## PROPOSED NMA

Victor & Apolline Lugger

Church Row

## Proposed Floor Plans - Third Floor & Roof

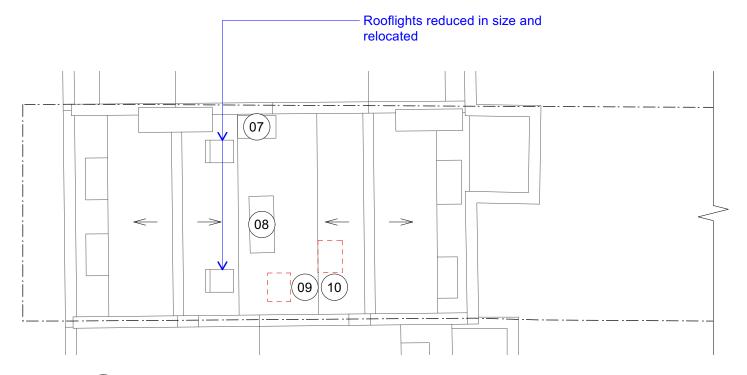
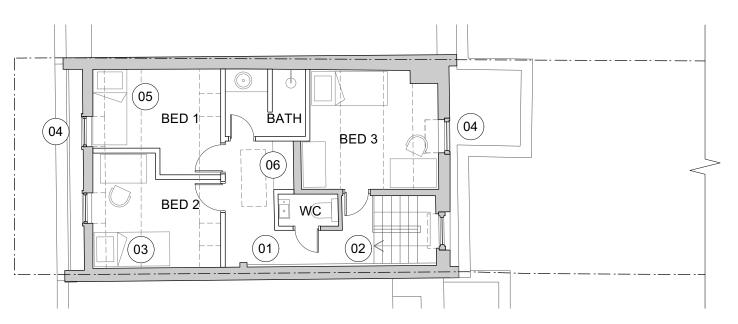
- Remove, carefully restore and reuse existing timber floorboards where possible
- Repair damage to existing stair
- Repair water damage to walls
- Overhaul existing timber window frames and repair damaged panes
- Reconfigure front room to create two bedrooms
- Update bathroom and WC spaces
- New skylight above bathroom
- Existing 1960's skylight adapted to roof access hatch
- Existing rotten roof access hatch filled, surrounding roof and ceiling made good
- Existing rooflight to WC
